# Access Compliance Report

## Public Rights-of-Way

Intersection ID: 15576	Main Street: LAWYERS_RD	Cross Street: IDLEWILD_RD_NORTH	Location: SW
ADA ID: E709719396FA	Ramp Type: PerpDiag	Initial Pass/Fail: Fail	Overall Compliance: No
			Severity Score: 21.25

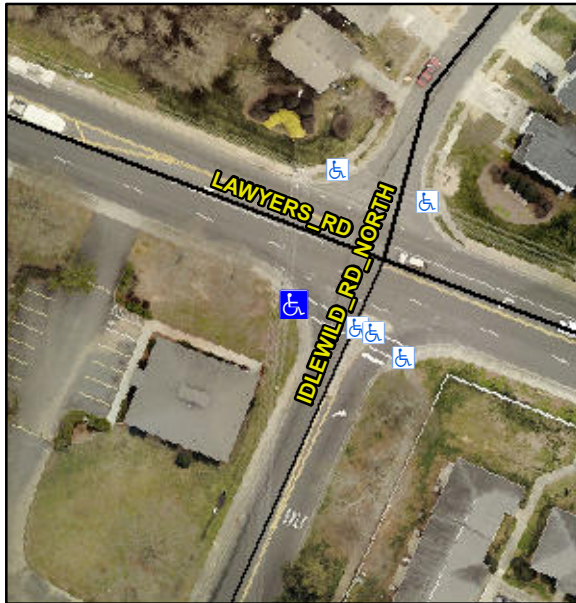
**Not Found, R304.5.1, R304.5.3**

Compliance	Description	Data	Compliance	Description	Data
N/A	Ramp Length (in)	59.0	Yes	Ramp Slope (%)	5.9
No	Ramp Width (in)	37.0	No	Ramp XSlope (%)	6.2
N/A	Flare Type LT	N/A	N/A	Flare Type RT	N/A
N/A	Flare Slope LT (%)	N/A	N/A	Flare Slope RT (%)	N/A
N/A	Flare Traversable LT?	N/A	N/A	Flare Traversable RT?	N/A
N/A	Landing Length (in)	N/A	N/A	DWS Provided?	N/A
N/A	Landing Width (in)	N/A	N/A	DWS Contrast?	N/A
N/A	Landing Slope (%)	N/A	N/A	DWS Length (in)	N/A
N/A	Landing X Slope (%)	N/A	N/A	DWS Full Width?	N/A
N/A	Landing Curb? (Y/N)	N/A	N/A	DWS Offset (in)	N/A
N/A	Shared Landing?	N/A			
N/A	Gutter Ponding?	N/A	N/A	Gutter Slope (%)	N/A
N/A	Gutter Lip Ht (in)	N/A	N/A	Gutter X Slope (%)	N/A
N/A	Painted X Walk1?	Yes	N/A	Painted X Walk2?	No
	X Walk 1 Direction	To SE		X Walk 2 Direction	To NE
N/A	X Walk 1 Width (in)	85.0	N/A	X Walk 2 Width (in)	N/A
	X Walk 1 Slope (%)	0.8		X Walk 2 Slope (%)	6.8
	X Walk 1 X Slope (%)	9.1		X Walk 2 X Slope (%)	0.1

**Remove & Replace Curb Ramp With Two New Directional Ramps or Equivalent.**
